MEMORANDUM

TO: Parks and Recreation Board

SUBJECT: Jimmy Clay Golf Course - 2.371 ac. and 0.935 ac.
Permanent Sanitary Sewer Use Agreements

REPORT ON:
MOPAC-WILLIAMSON CREEK LIFT STATION RELIEF MAIN, PHASE ONE

PROPOSED SINGLE RESIDENTIAL BOAT DOCK
 11 2 2021

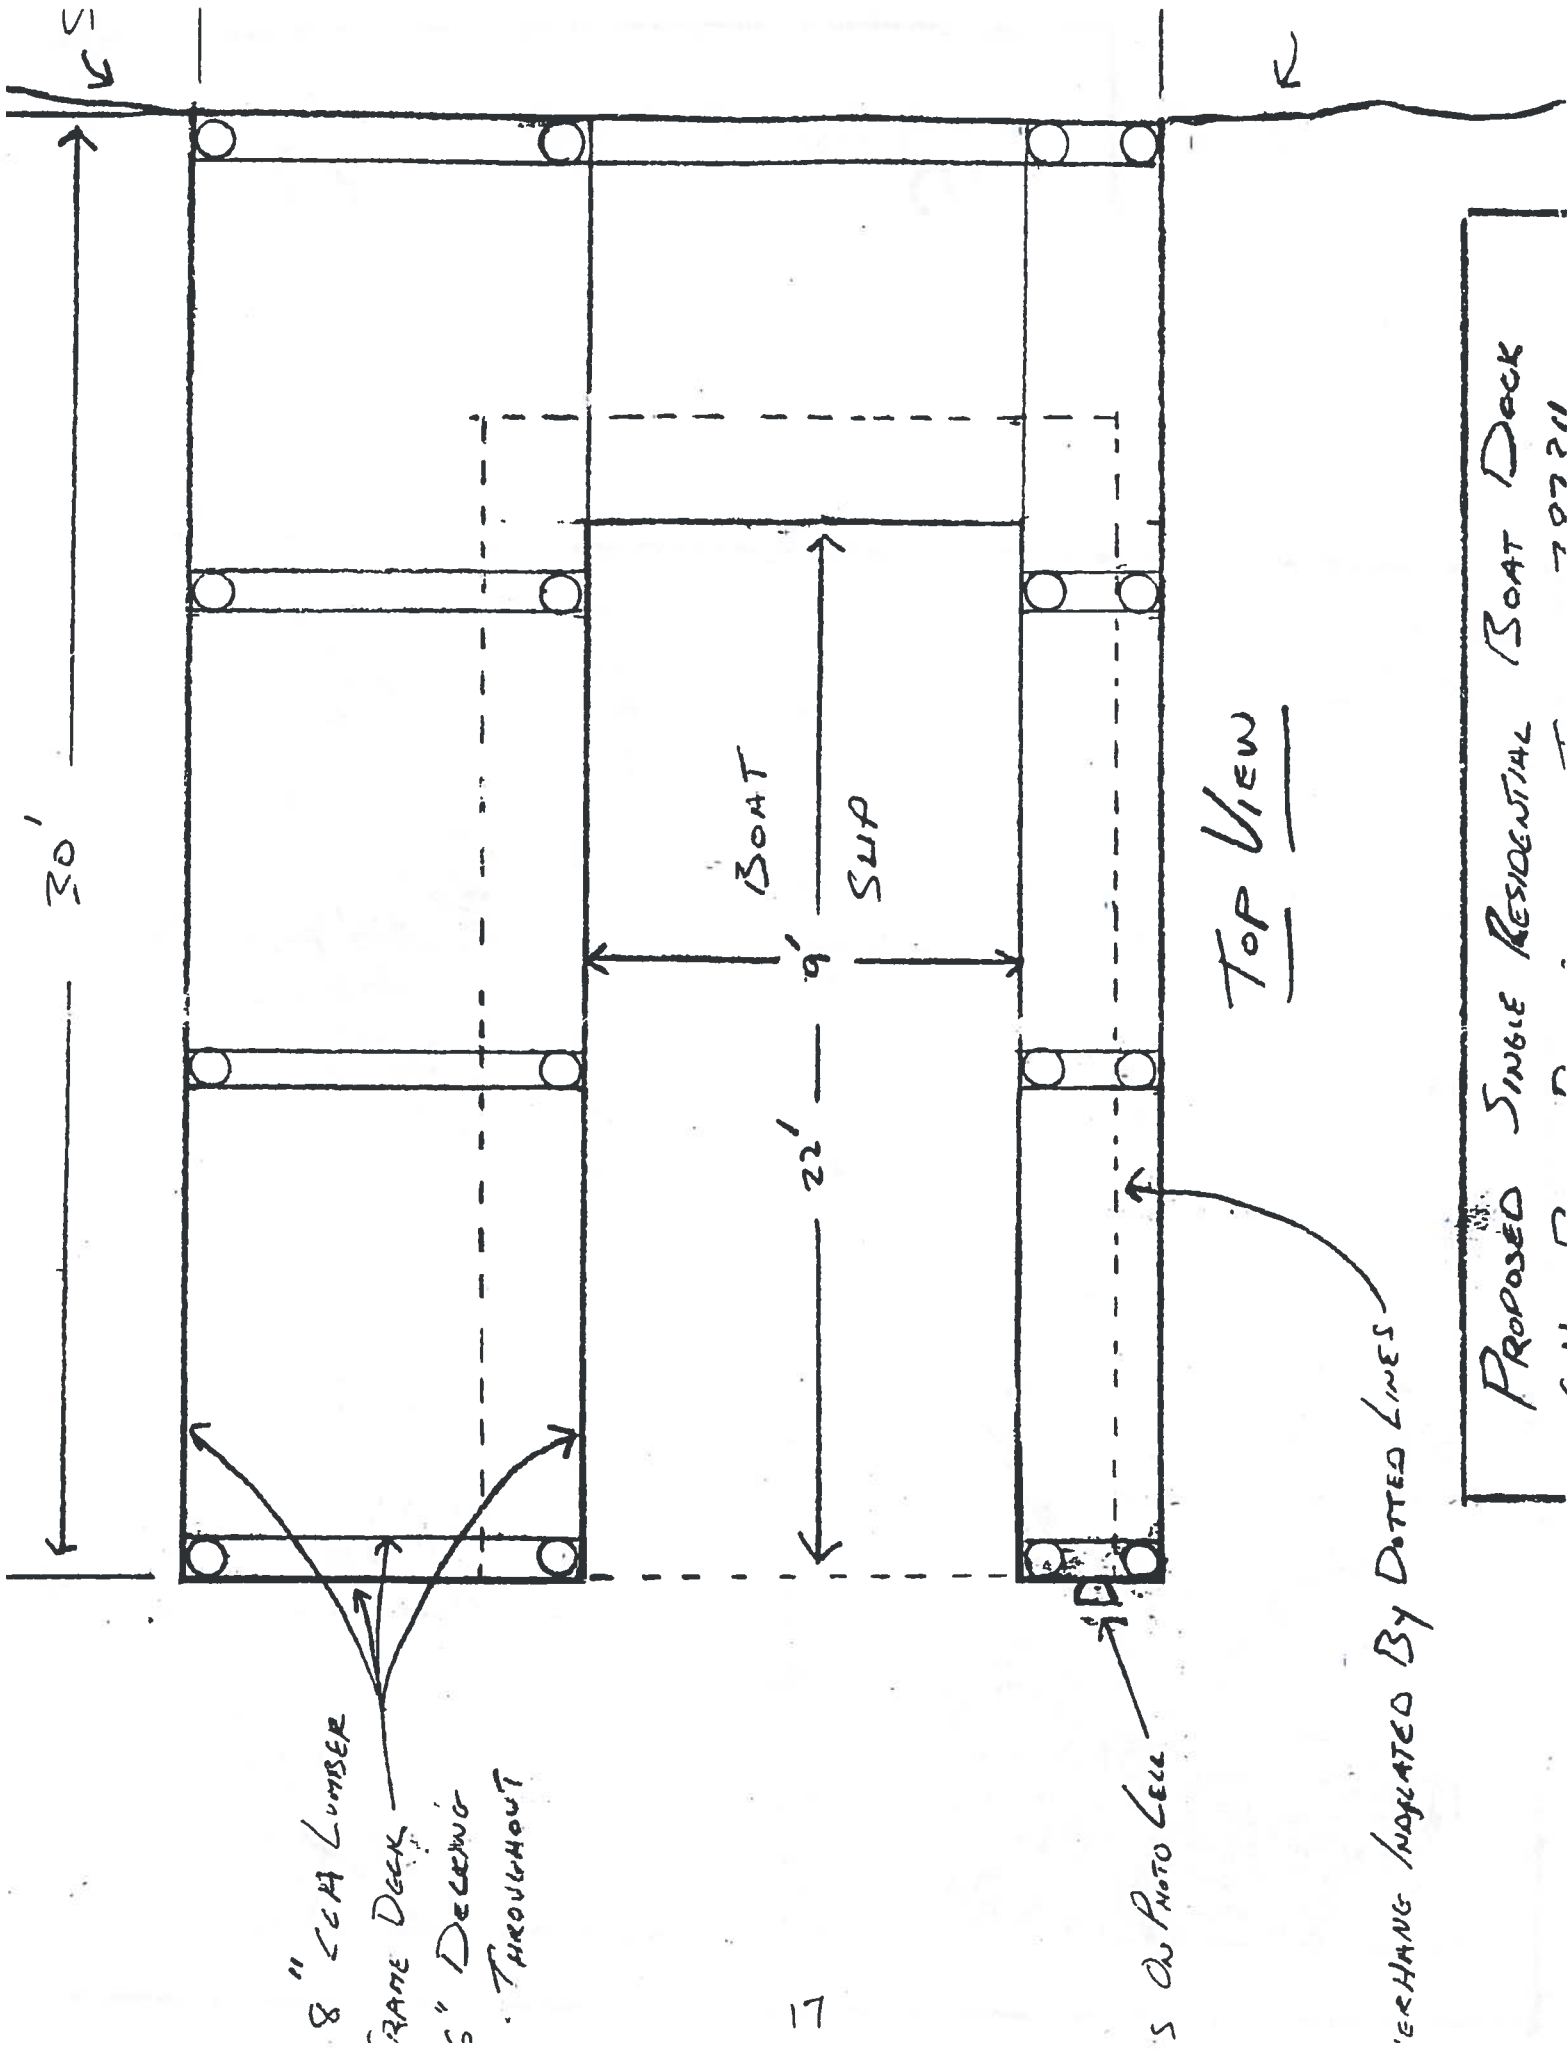
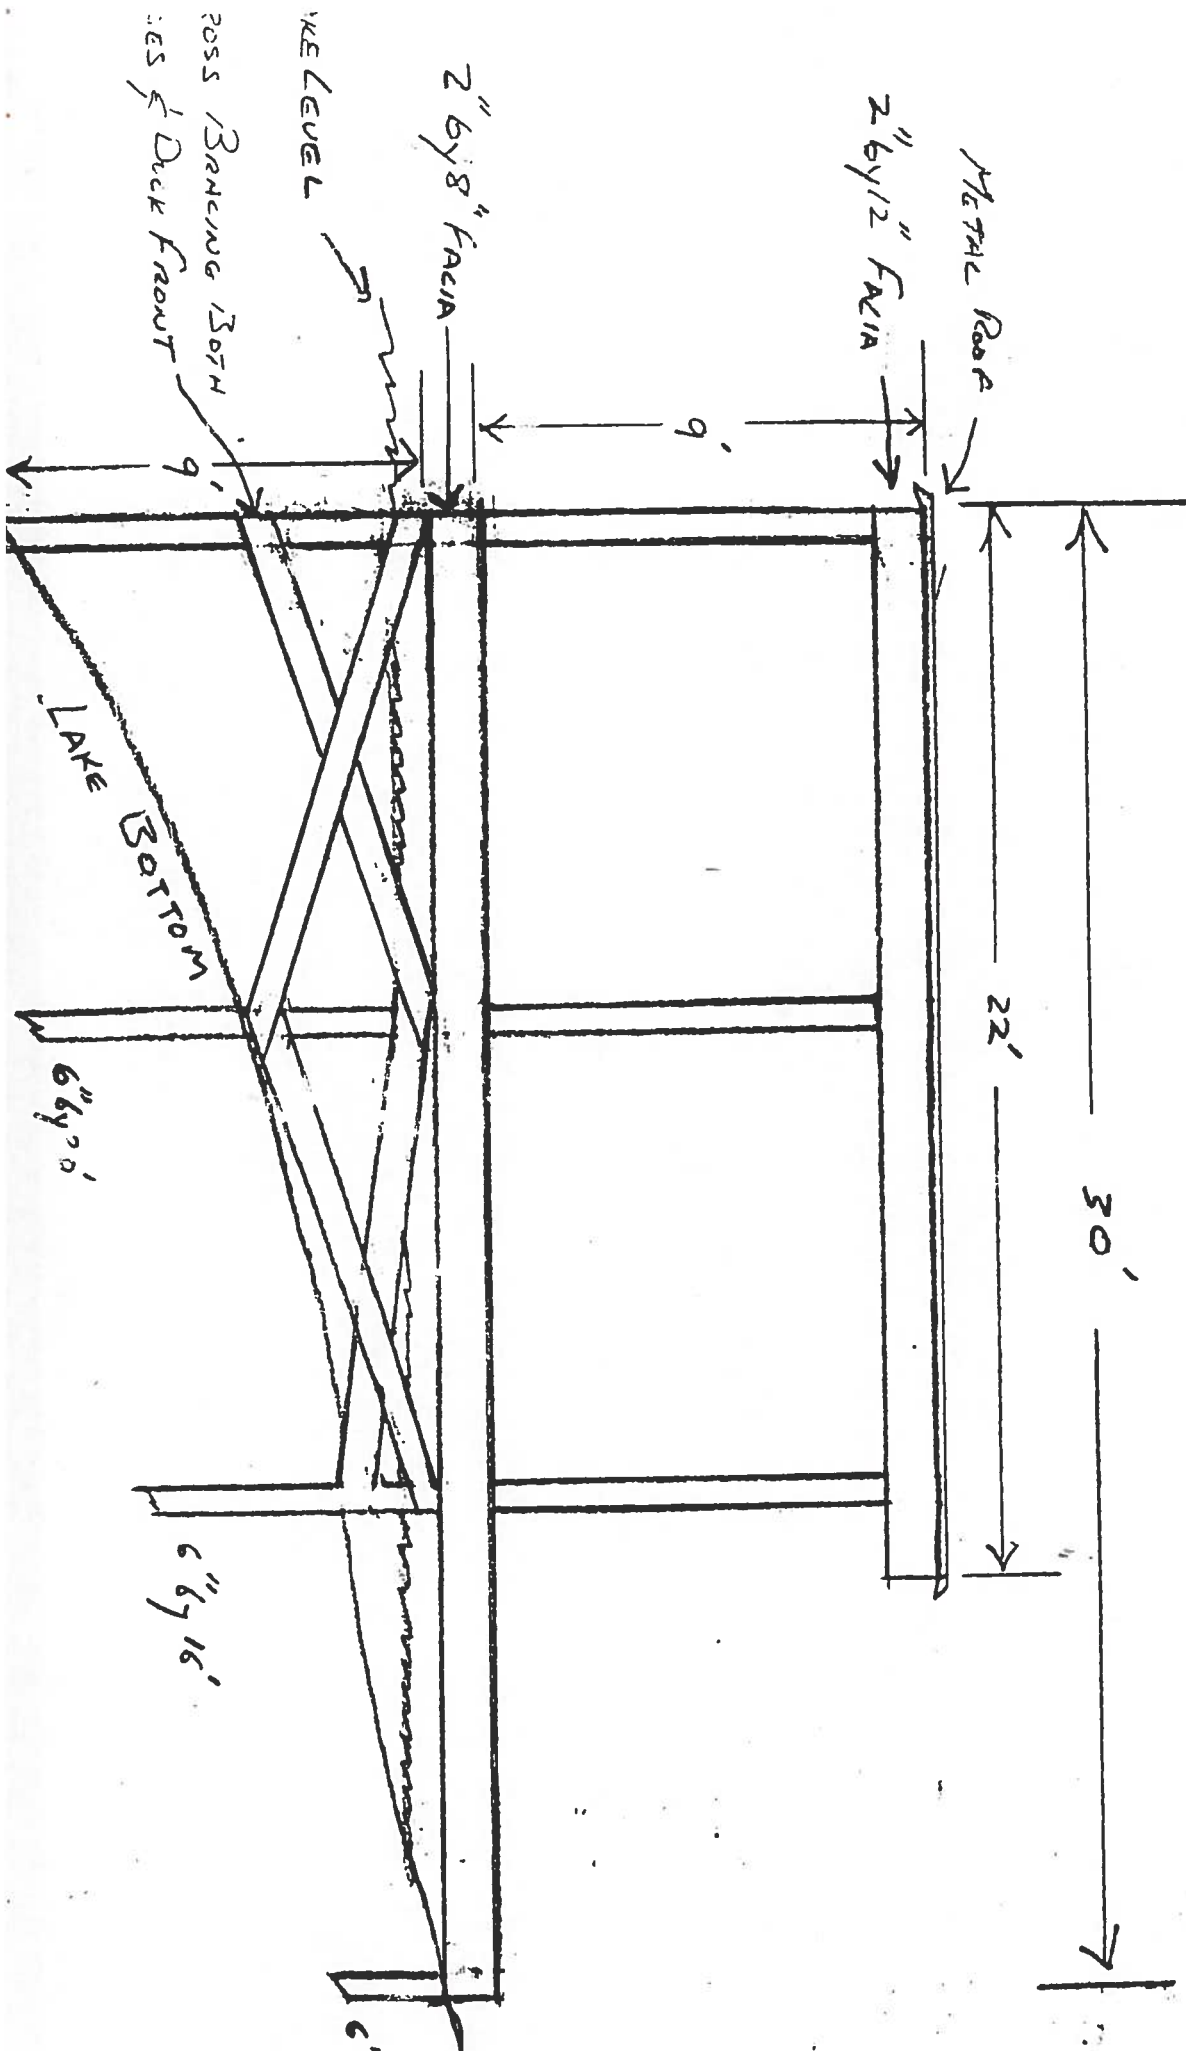
I recommend approval of the request to construct a covered single-slip dock at 611 River Road, in accordance with Site Plan # SP-95-0181D; however the applicant's attention should be drawn to the fact that this section of the lake is subject to high water levels and water velocity during storm events when discharges occur from Mansfield Dam. To avoid possible damage to the boat dock and to stored watercraft, consideration should be given to utilizing a floating structure.

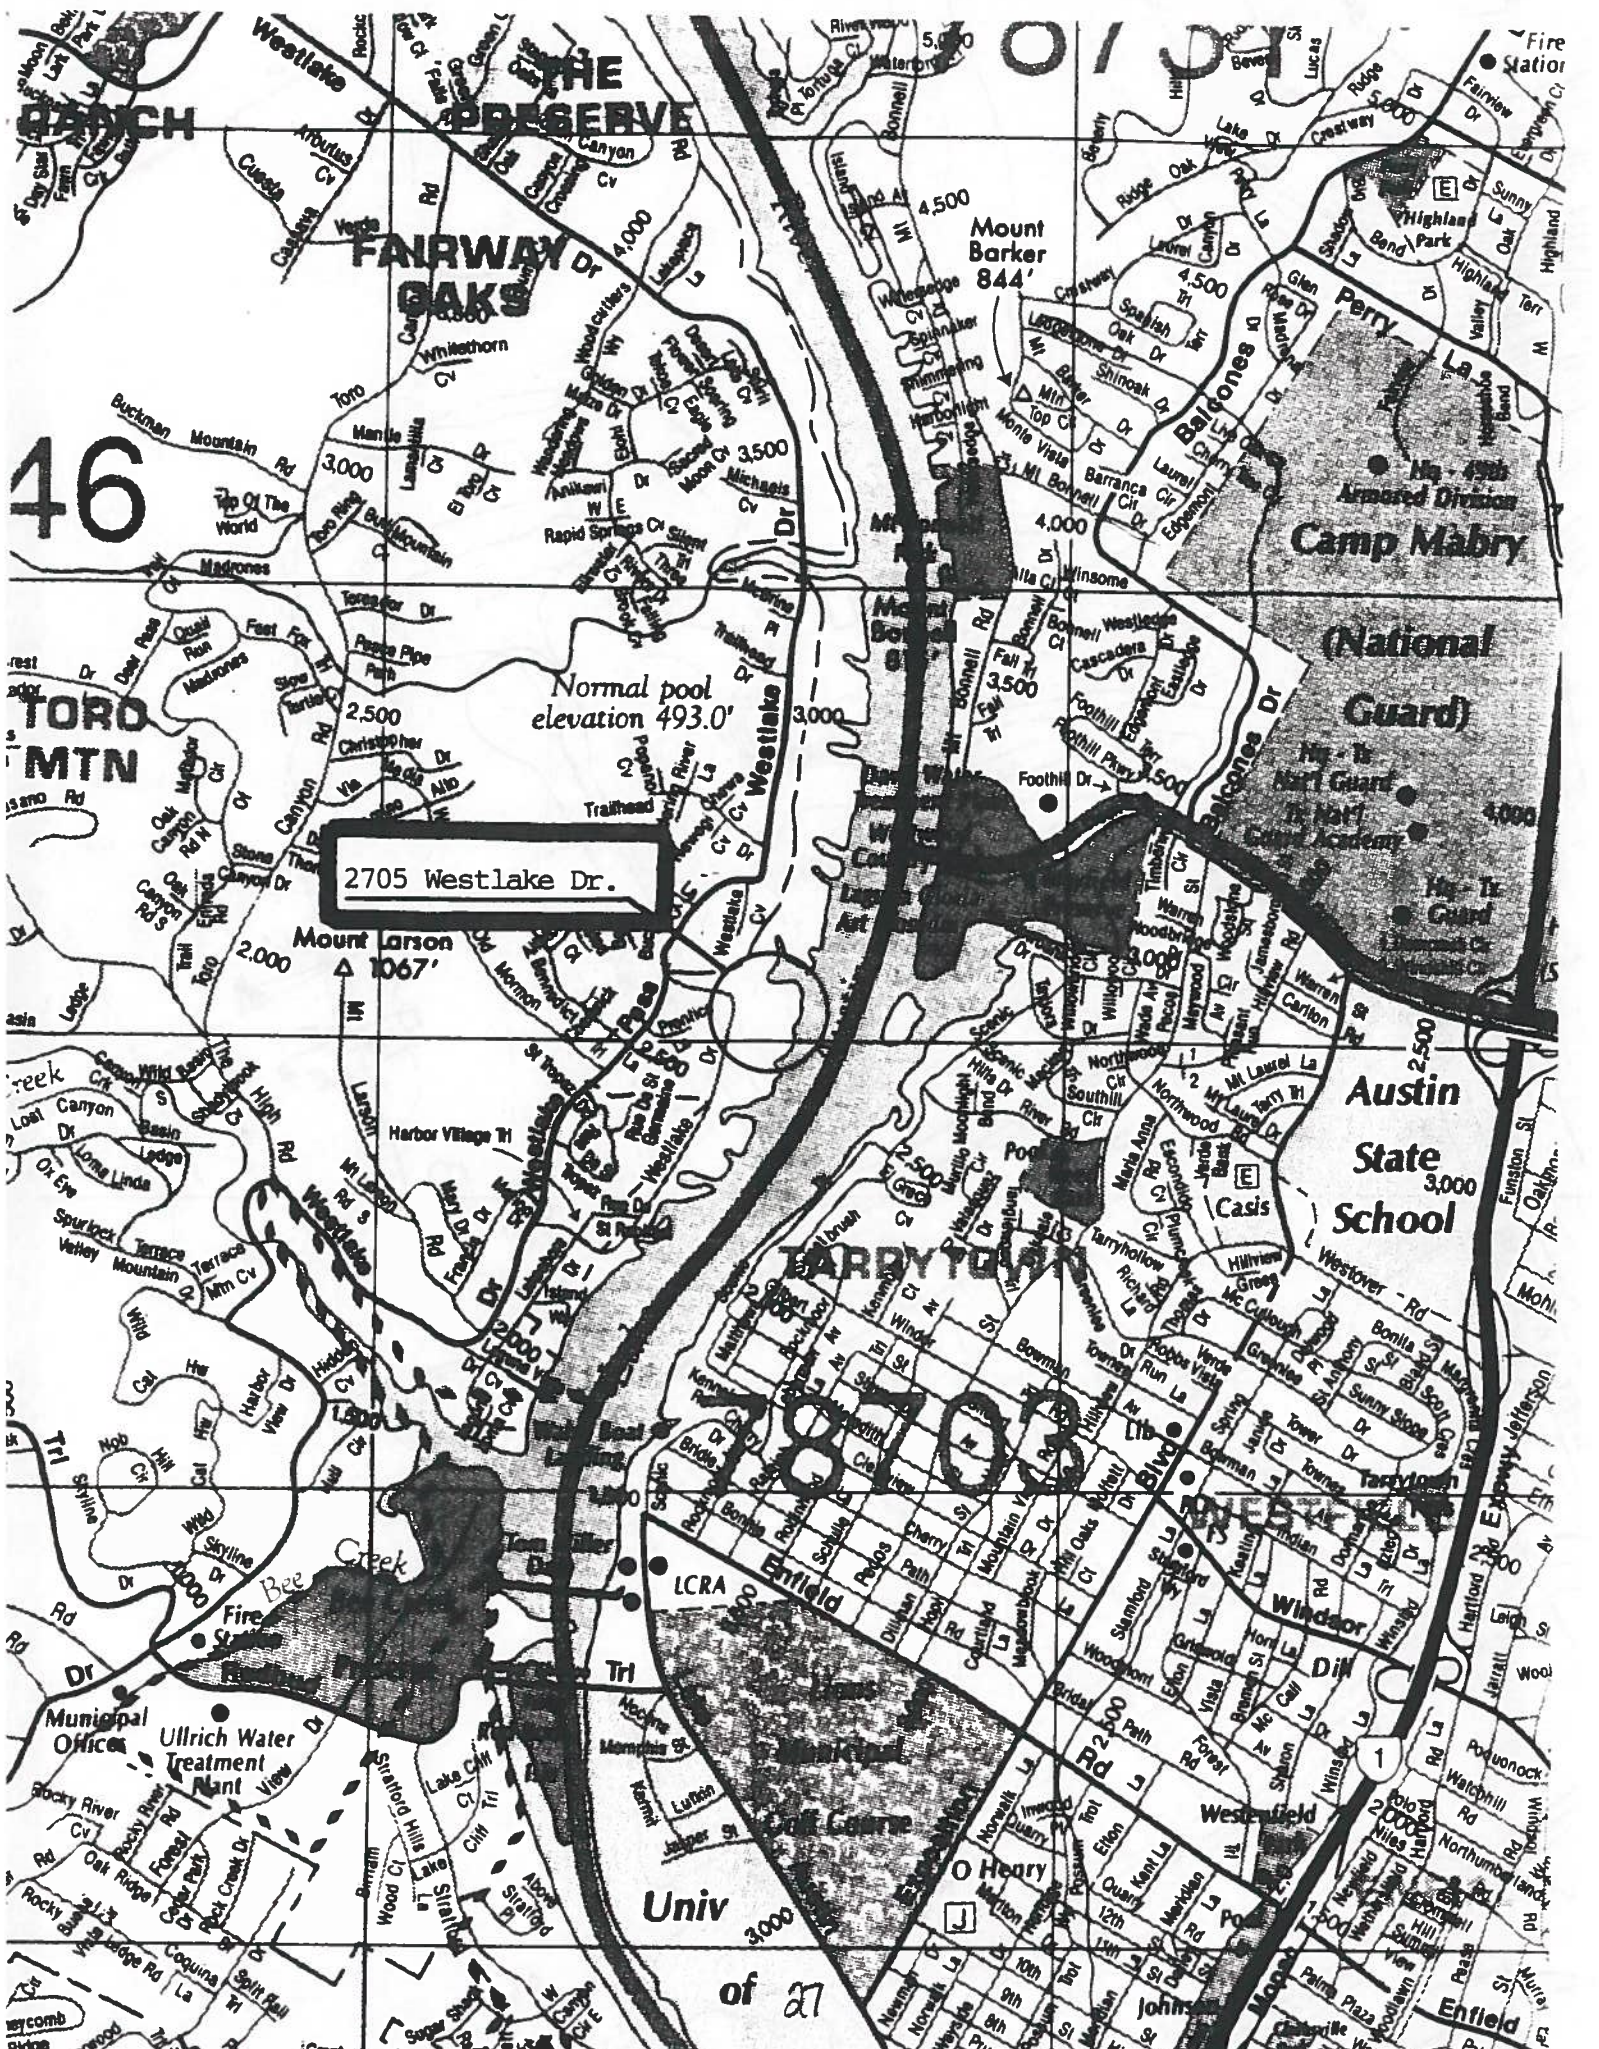
The site plan notes a swimming area between the dock and the point of shoreline to the south. Part of the swimming dock will be roofed and partially enclosed with mosquito netting.

In accordance with Article VI, Section 13-2-795 of the City of Austin Site Development Regulations, it is our intent that the swimming dock location and length will improve the life safety of swimmers and reduce the existing hazard to navigation. Our reasons are as follows:

- The existing natural point of shoreline sharply juts 50 feet in to the lake. In low light conditions, this point is a hazard to navigation.
- The roofed swimming dock will be quite visible and well lit (including amber lighting at its furthest point). The dock itself, extending 40 feet, will provide a visual cue keeping boaters well away from the natural point of the shoreline jutting into the lake.
- By the extension of the swimming dock, a protected swimming area is created between the dock and the natural shoreline improving swimmer life safety.
